PLANNING COMMISSION
MEETING AGENDA
JUNE 13, 2023
7:00 P.M.

Wawa
370 and 380 Glensprings Drive
Development Plan Review
Application# 2023-0312
June 13, 2023

WAWA CONVENIENT STORE
370 GLENSPRINGS DRIVE
PLAN REVIEW APP #20230312
23020108
JUNE 8, 2023

PLANNING COMMISSION
ENGINEERING REVIEW

Drawing Title:
SITE PLAN

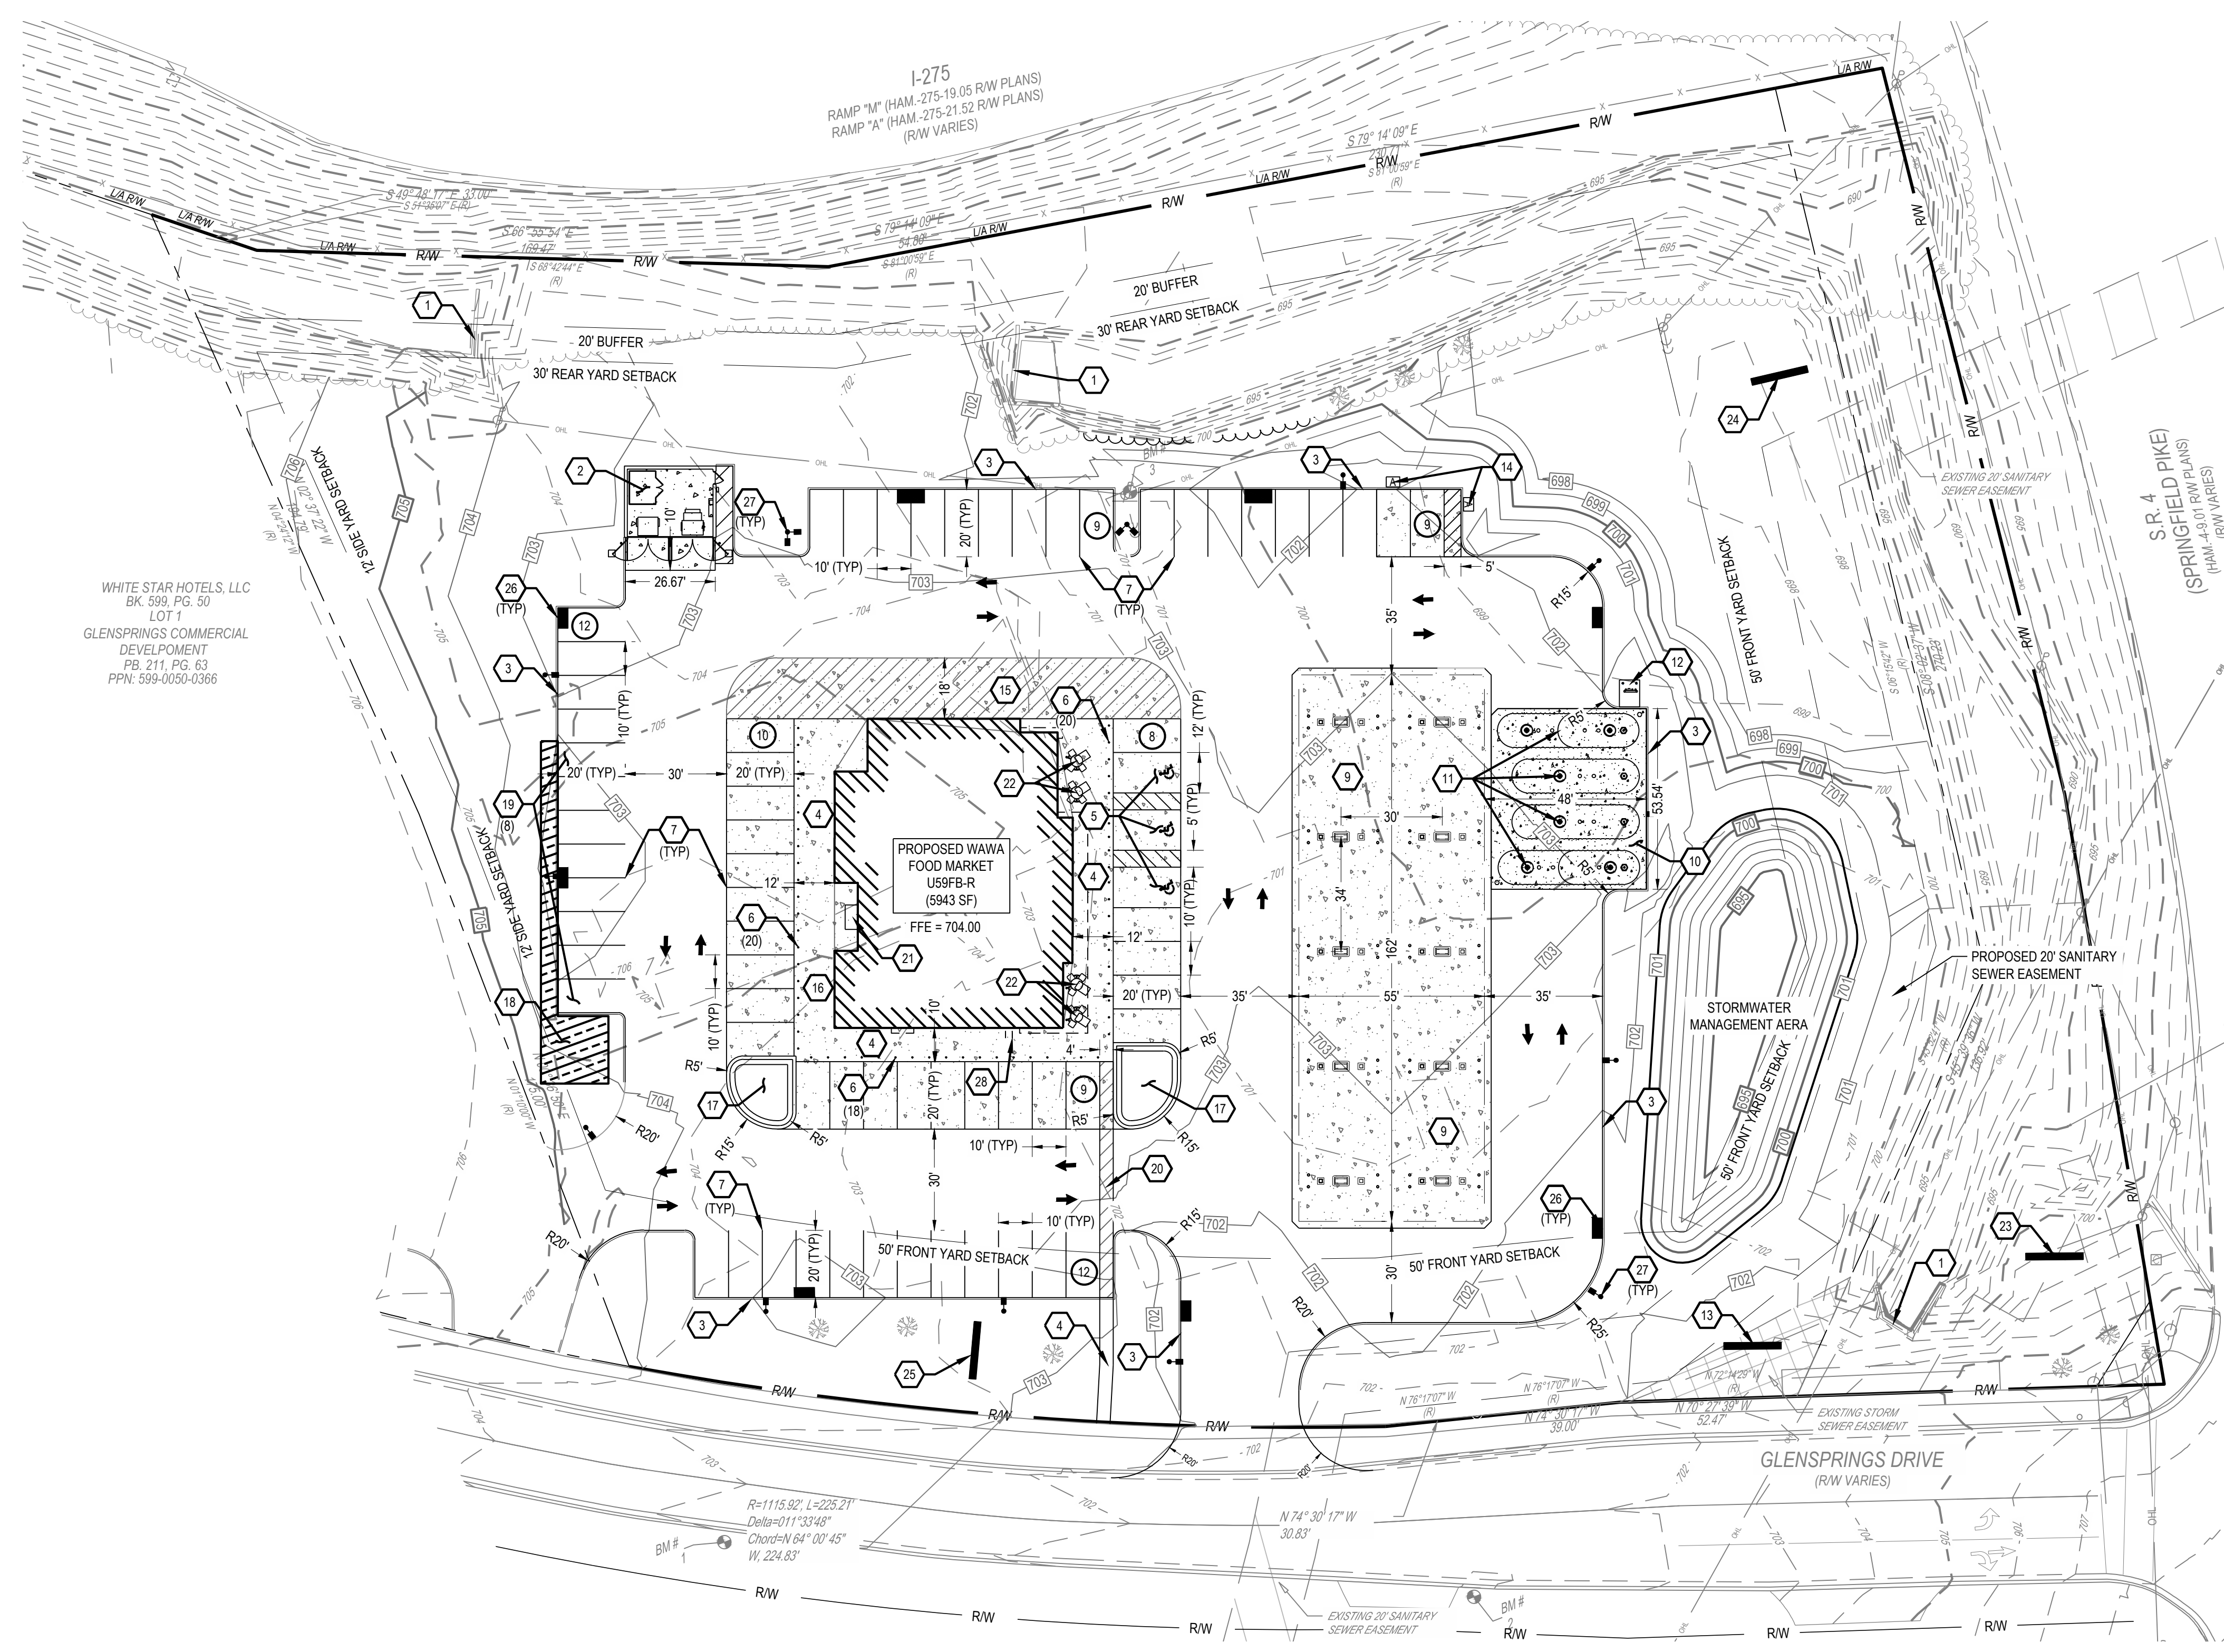
- 5) Bicycle parking is required per Section 153.302 (S). A bike rack is indicated on the south elevation.
- 6) Two stacking spaces are required for each pump island per Section 153.304. Location needs to be provided on the site plan to indicate compliance.

- 8) Details, consistent with the Standards of Section 153.253(E)(8), be provided for the proposed outdoor dining area.
- 9) The two required (Section 153.304) stacking spaces for each fuel pump need to be indicated on the site plan.
- 10) The only outdoor storage or display of items for sale be limited to ice and propane adjacent to the west building elevation.
- 11) All roof and ground mounted equipment be screened per Section 153.254(C).
- 12) A revised landscape plan to address staff comments be submitted to the City for review and approval.
- 13) The percentage of non-earthtone colors be provided for each elevation.

- a. The submitted site plan does not indicate how or if the existing site stormwater is being detained however stormwater detention for the proposed development will be achieved by a proposed detention basin east of the fueling canopy. The Applicant is to provide all data and design information used for the design of drainage facilities and for determining downstream runoff information.

- (b) Treatment of at least 20 percent of the WQv.
 - (c) A combination of (a) and (b).
 - a. The submitted site plan dated May 30, 2023, noted that the proposed site impervious area is 1.17 AC (33%). The preliminary plans do not note the proposed change in site impervious area however the post-construction water quality is required to be addressed. The Applicant shall submit drainage calculations for review with the construction plans.

- i. The Applicants review comments response letter dated May 25, 2023, indicated that they will show all the necessary storm water control measures for detention within the construction plans for approval.

- i. The Applicants review comments response letter dated May 25, 2023, indicated that they will show all the necessary storm water quality control measures within the construction plans for approval.

3 SIDE - SOUTH ELEVATION
3/16" = 1'-0"

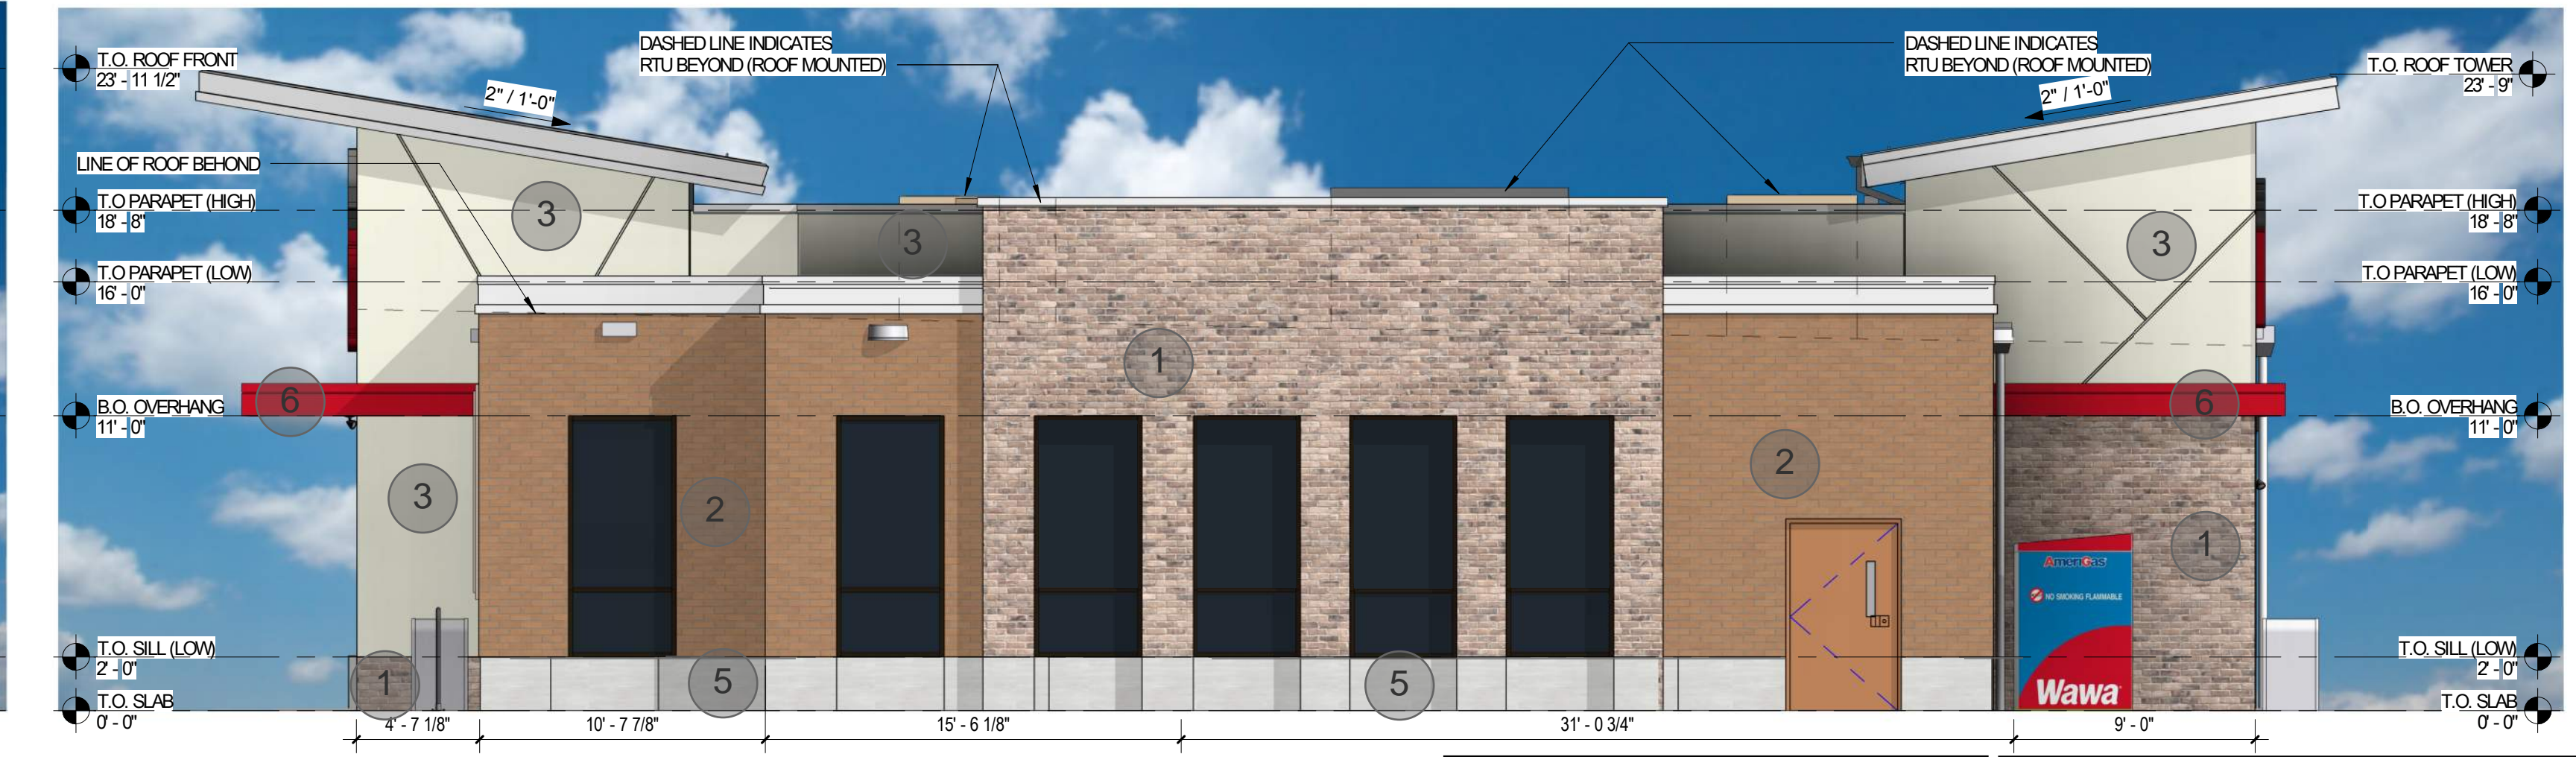
- 5) Planning Commission determine if the reduced transparency (30%, 25.5%, 20%, and 16%) on elevations below the 35% required is acceptable.
- 6) The light fixtures and poles be dark bronze in color. Planning Commission approve the proposed light levels at the east (3.8 footcandles) and west (3.6 footcandles) access points. Planning Commission approves the proposed average light level of 9.43 footcandles under the canopy.
